DRAFT WATKINS CREEK TMDL
PUBLIC COMMENTS

Public Notice
June 1 – July 16, 2012

Watkins Creek
WBID # 1708

St. Louis County, Mo.

Modified Watkins Creek Segment at Upstream Sampling Site.

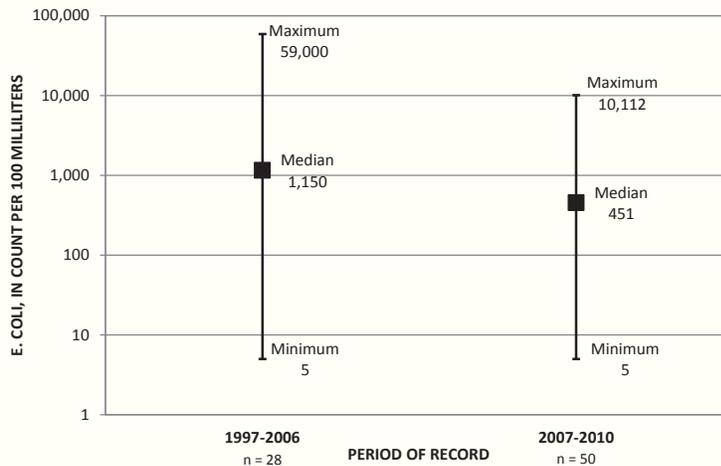
b. Variability of *E. coli* density between sample sites suggests that grouping data is inappropriate.

Existing load estimates in the TMDL were developed using *E. coli* data collected from five sampling locations – only two of which are located in the classified segment of Watkins Creek. The implicit assumption of grouping data from all five locations is that the data are comparable and representative of the classified segment. However, a review of the dataset indicates *E. coli* levels vary significantly between sites. For example, *E. coli* levels are notably greater at site 1708/1.4/4.3 (apparently mislabeled as 1708/1.2/4.3 in the TMDL), which is located 4.3 miles upstream from the classified section of Watkins Creek. While these data, if appropriately analyzed, may be useful for understanding bacteria sources and watershed contribution, they should not be used for the modeling approach used by the Department. Therefore, as indicated above, the Department should either use an appropriate watershed model and or limit the evaluation to data collected in the classified portion of Watkins Creek.

FIGURE 4. Comparison of median illness risk for adults when total ENT concentration (at 35 cfu 100 mL⁻¹) is attributed to a mixture of primary POTW effluent (sewage) and seagull feces (gulls).

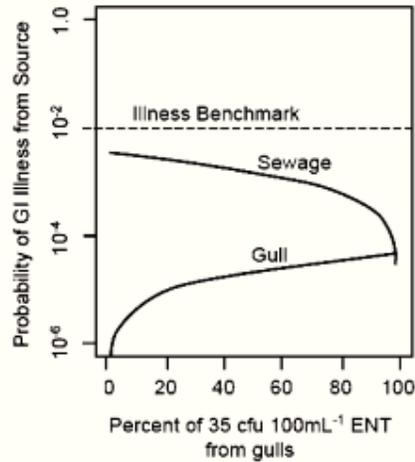
Recent QMRAs by USEPA contractors have shown that setting appropriate recreational indicator bacteria limits (i.e., corresponding to illness rates of 8-9 per 1,000 WBCR exposures) requires an understanding of bacteria sources (Schoen and Ashbolt 2010, Soller et al. 2010). As shown in Figure 4 from Schoen and Ashbolt (2010), when percent of bacteria from non-human sources (in this case gulls, as shown on the x-axis) is above roughly 80%, the cumulative illness risk (or the sum of the gull and human/sewage risk curves) is roughly half the USEPA's tolerable illness rate

(as indicated by the “illness benchmark” horizontal line). Stated another way, when the percent of bacteria indicators from human fecal sources is low, default recreational criteria are overprotective and can be safely increased. Further supporting this understanding, as shown in Figure 3b from Soller et al.(2010), predicted illness risks associated with recreational contact with a variety of fecal sources all at uniform concentrations of 126 col/100ml *E. coli* indicate that illness rates (and therefore appropriate recreational limits) are very much a function of bacteria source. While some source tracking information is available within the USGS study, a phased TMDL approach would allow the collection of additional source data given the very rough nature of the USGS source tracking methods.

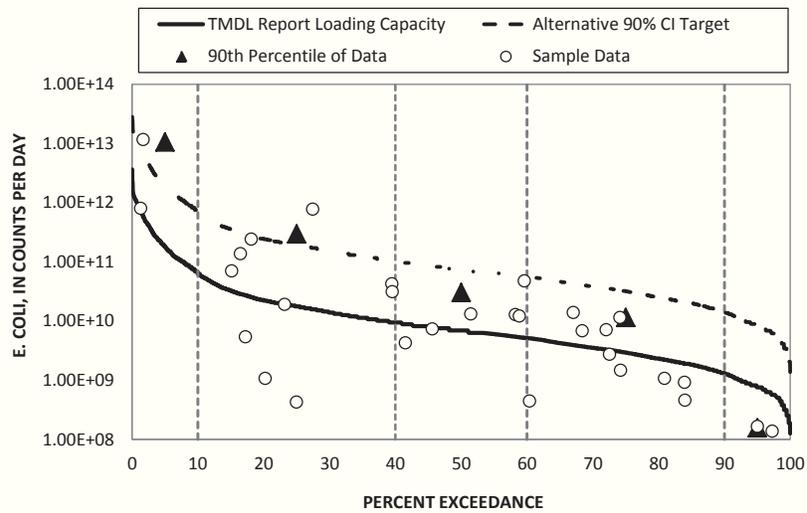
b. The load duration curve must be adjusted so that sample data and TMDL target have comparable averaging periods.

As discussed above, technical guidance developed by the USEPA (2007c) suggests that load duration curves should be calculated from data and criteria that have the same averaging period. Data used in the TMDL report did not have the same averaging period. In the TMDL, the Department multiplied the recreational season geometric mean criterion by a daily flow value to obtain the loading capacity for Watkins Creek. This loading capacity was then compared to daily bacteria measurements and geometric means of data from various daily flow exceedance intervals.

The correct way to calculate the TMDL would be to either 1) convert the bacteria and flow data into recreational season geometric mean values and compare them to the geometric mean water quality criterion or 2) convert the recreational season water quality criterion to a daily value and compare it to the daily data. Either method would provide a more accurate representation of existing loading conditions relative to intended water quality criterion. The first method of converting the sample data to a recreational season geometric mean is complicated by the fact that limited data are available from most years to calculate a representative geometric mean value. However, the second method of converting the average water quality criterion into a daily value is a straightforward process. Appendix B of USEPA's (2007c) technical guidance includes an example bacteria calculation that converts a non-daily bacteria criterion to a daily value using statistical procedures outlined in USEPA (1986). This example is directly applicable to Watkins Creek and is illustrated in the following paragraphs.

Figure 11. Box Plots of BMP Study Geometric Means for Fecal Coliform by Selected BMP Category

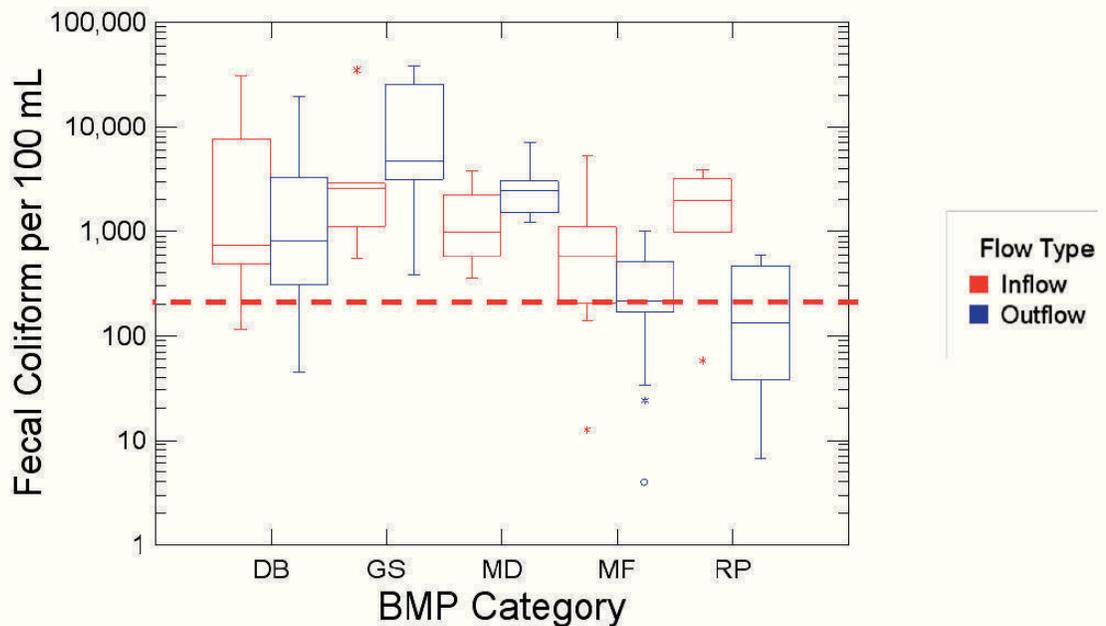
expressed average period or duration. The ability of other BMPs, such as infiltration or capture/reuse systems, are constrained by soil infiltration conditions, available open space, land availability, reuse opportunities, and infrastructure or utility conflicts. The MEP standard must be employed in implementing MS4 controls, including the development and implementation of the Watkins Creek TMDL.

Source: MS2 2012, WatkinsDevelopmentInfo, Watkins20120808.mxd, FC

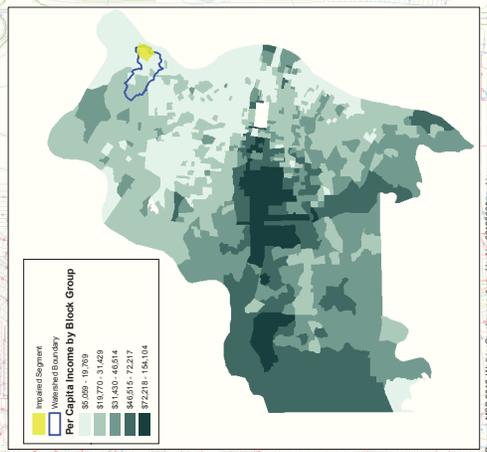
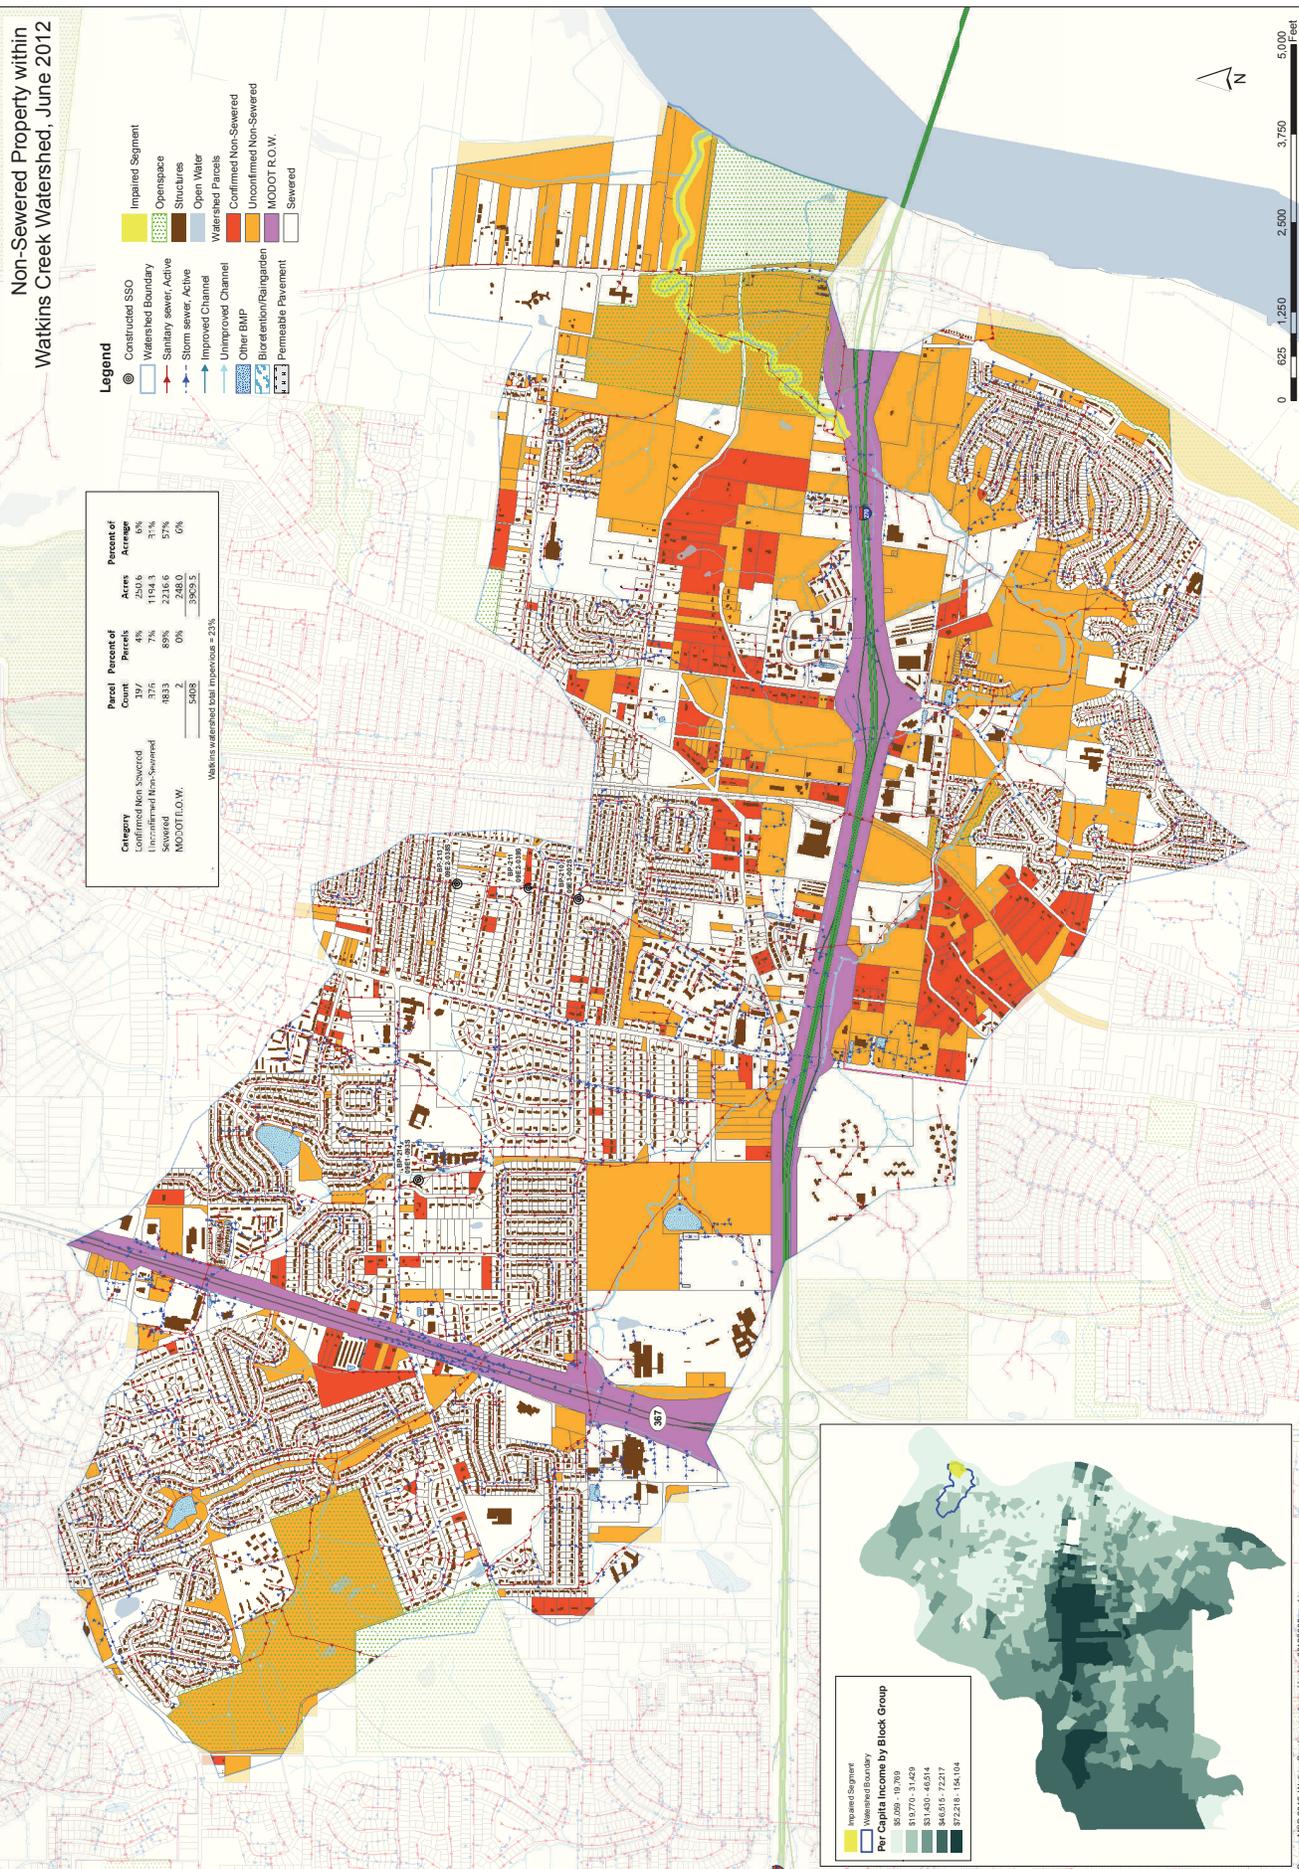
Therefore, with these comments the District is providing the Department with more detailed GIS layer of land use data in the St. Louis area. The attached figure provides several key findings that may aid subsequent revisions to all TMDLs in the District’s service area, which are discussed below.

These datasets can and should be used for several purposes in the TMDL and implementation plan, including source identification and characterization, load and wasteload allocation calculations, and prioritization of implementation actions. The District requests that MDNR consider such data with subsequent revisions to the TMDLs.
